January 9, 2024

From: Mark Mariano, PE, CPO
Team Leader
Weston & Sampson Engineers Inc.
85 Devonshire Street
Boston, MA 02109

Memorandum – Budlong Park Pool, Cranston RI – Historical Review

Figure 4.5.12.1: Plumb Pool Walls: Cross-Section

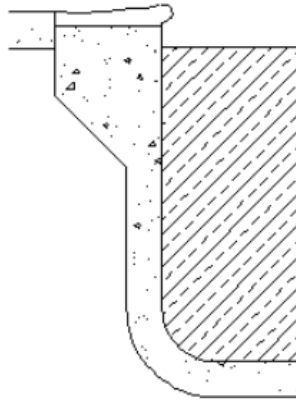
14. On the deep end pool wall there is a wall obstruction. It appears to be part of the pool as the pool was liner-ed over it. This a violation of MAHC [4.5.12.4](#) – No Protrusions, Extensions, Means of Entanglement, or Obstruction. This requires walls to be within +/- 3 Degrees in vertical tolerance. There are areas of the shallow that seem to be more than 3 % of tolerance.

Plumb within a +/- 3 degree tolerance.
